Re: AOI #50 Under EPA's RCRA Corrective Action Program  
DUCO Stores – Building 34  
660 South Boulevard East, Pontiac, Oakland County, Michigan  
Facility ID No. 0-0018277  
MDEQ Confirmed Release Nos. C-0235-90, C-0776-90, and C-1831-91

## ATTACHMENT A

### MDEQ COMMENTS AND CRA'S RESPONSES

figure 3.2  
 VERIFICATION SAMPLE LOCATION PLAN  
 TRUCK PRODUCT CENTER WEST - BUILDING 34 EXCAVATION AREA  
 GM TRUCK GROUP  
 Pontiac, Michigan

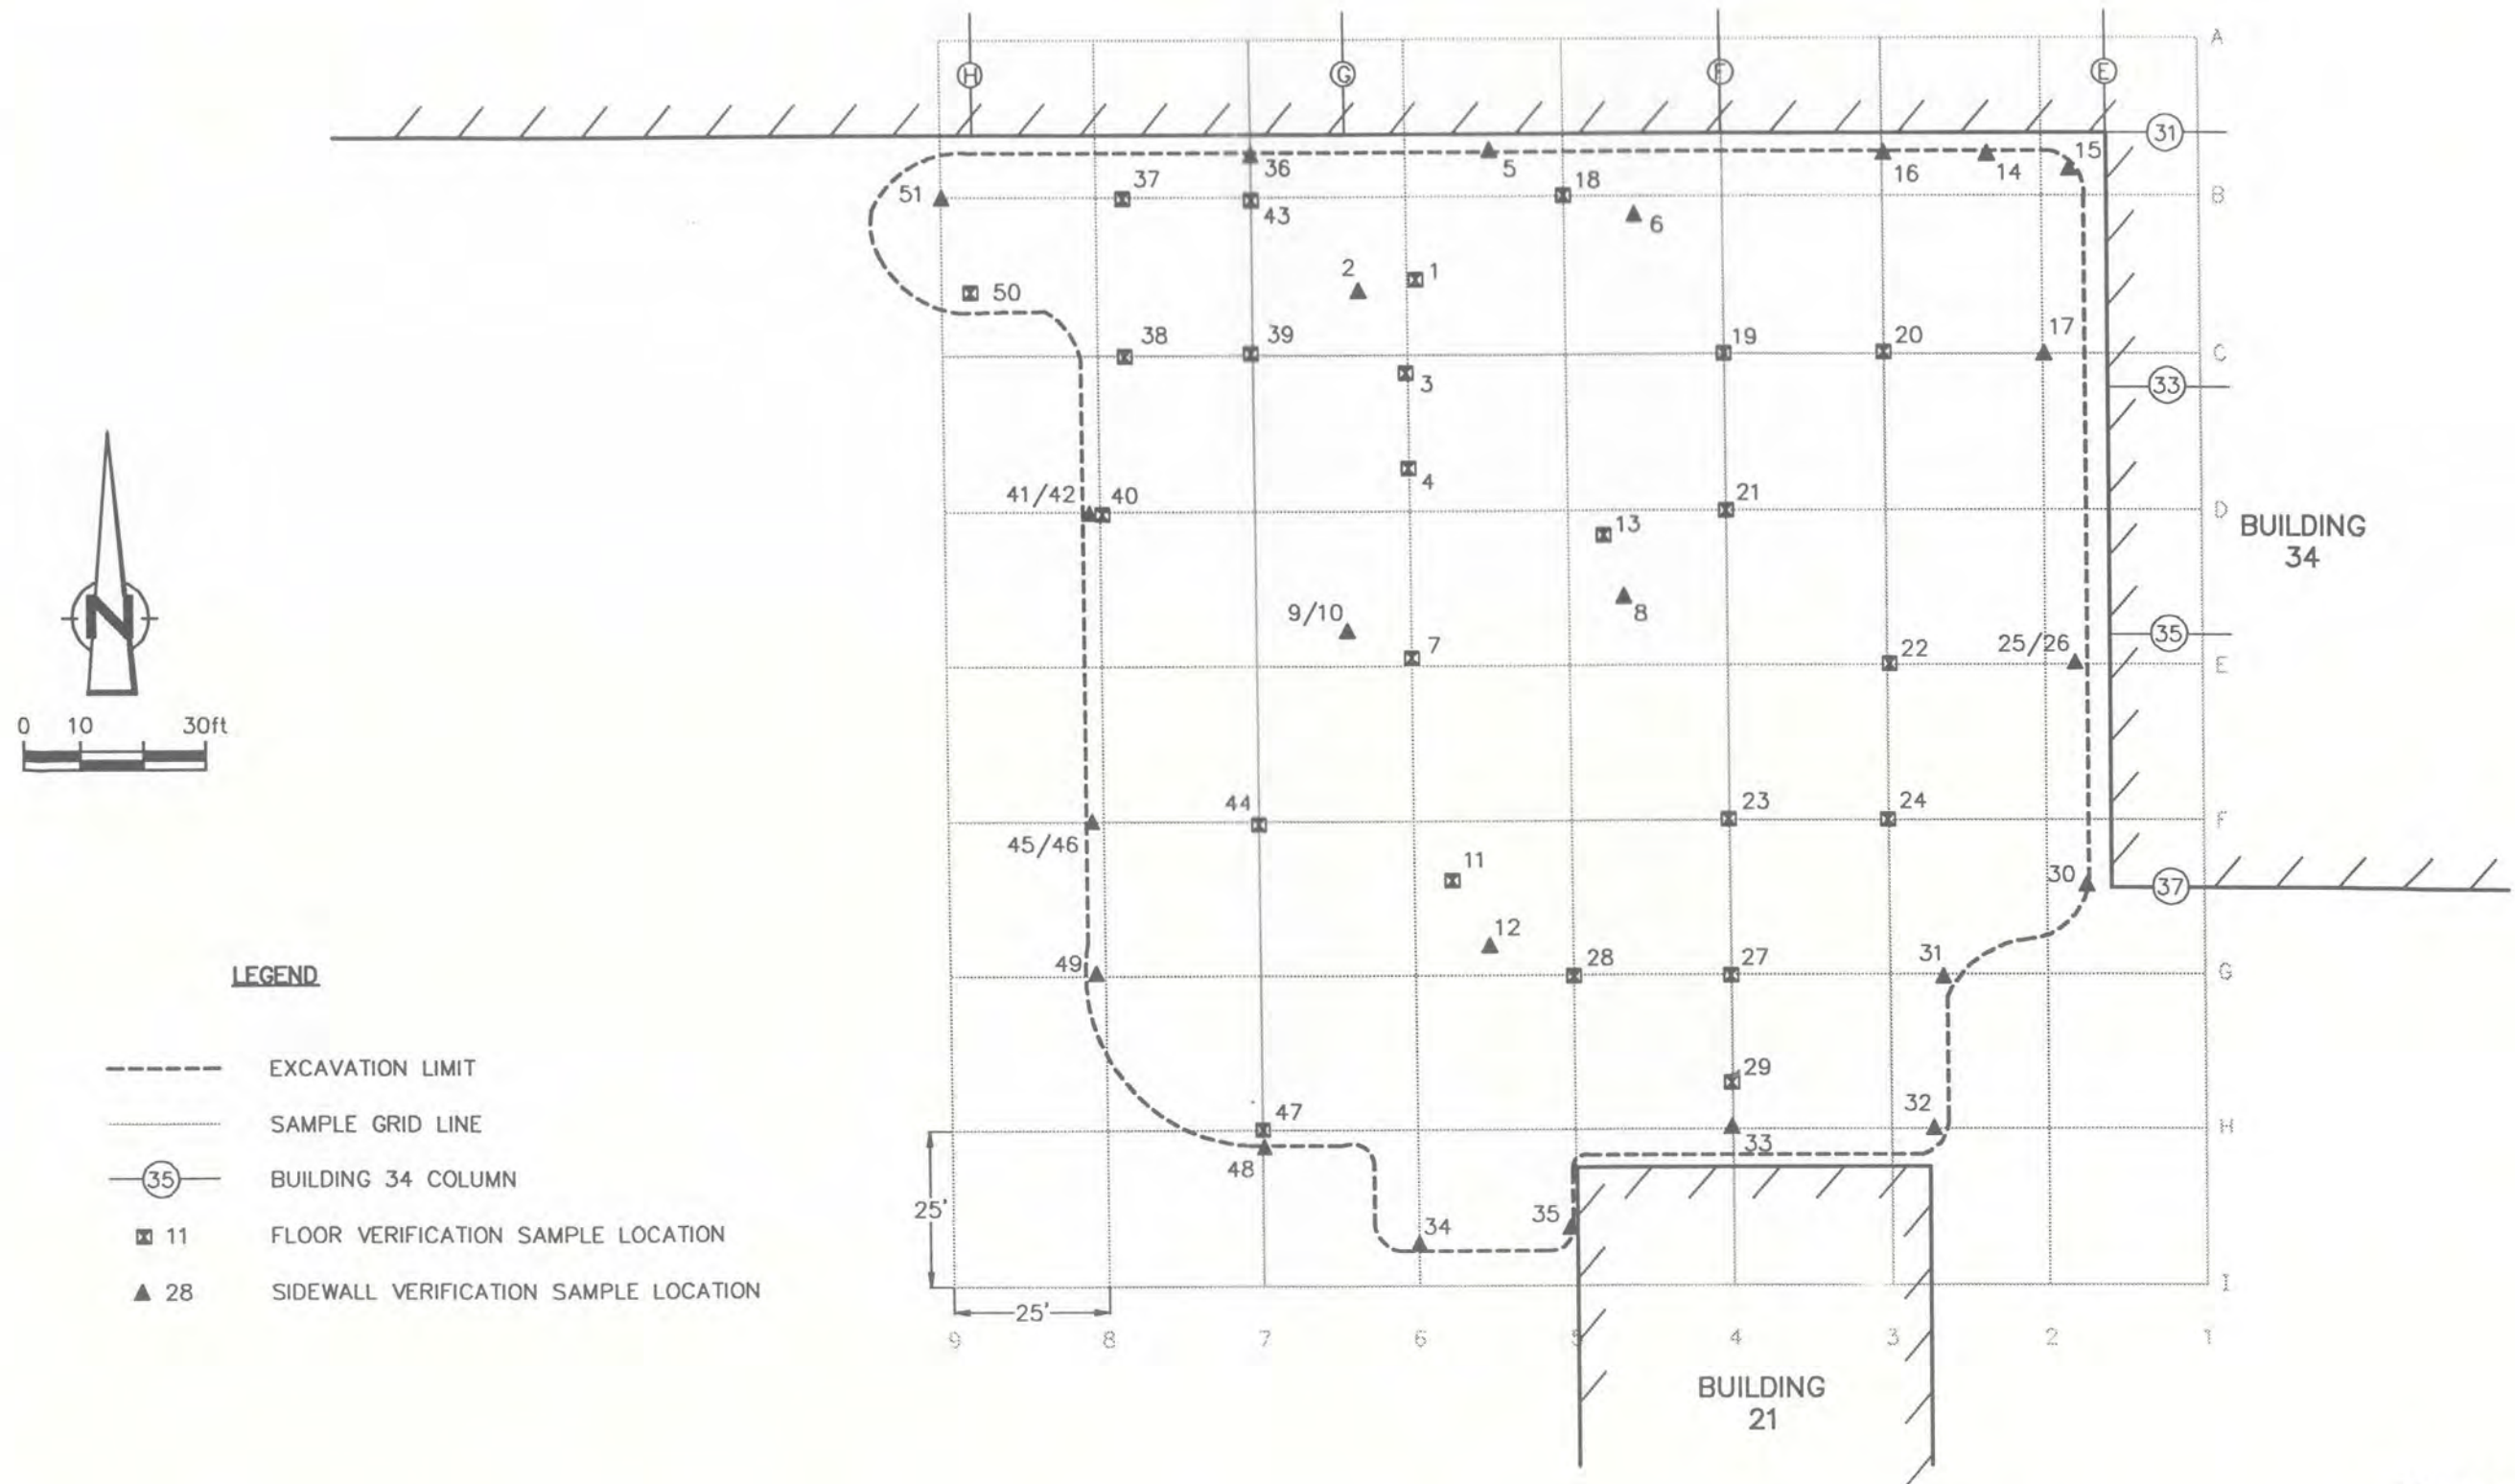
*The report lacks sufficient justification for the Verification of Soil Remediation (VSR) samples collected. According to the information of Page 7 of the October 10, 2010, CRA report, the VSR sampling does not appear to have been biased sampling (i.e. "the majority of floor and sidewall samples were predetermined").*

The MDEQ comment is in regard to the verification sampling performed at the time of the October 1997 excavation. CRA collected 49 soil samples from the excavation including 24 samples from the excavation floor and 25 samples from the excavation sidewalls. CRA completed VSR sampling in accordance with the MDEQ-ERD Verification of Soil Remediation Guidance Document (April 1994, Revision 1), which was the applicable guidance at that time. When verifying remediation of medium- or large-sized areas, statistical sampling strategies are generally recommended. Therefore, biased sampling was not completed. Medium-sized areas are generally defined as areas ranging from ¼ acre to three acres. Because the size of the excavation met the definition of a medium-sized area (approximately 18,000 square feet), the number of samples to be collected was determined based on application of a sampling grid for the area to be sampled. The majority of floor and sidewall sample locations were predetermined unless field evidence of impacts were observed, then biased samples were collected. As described in Section 3.2.1 of the Draft for Review Building 34 Excavation Summary Report, "Based on an estimated area of the excavation, a sample grid with a grid interval of 25 feet was established". Therefore, based on sampling protocol following applicable VSR guidance and the technical adequacy of the sampling, CRA does not believe additional verification sampling is necessary. Figure 3.2 from the Excavation Summary Report (attached) presents the Verification Sample Location Plan.
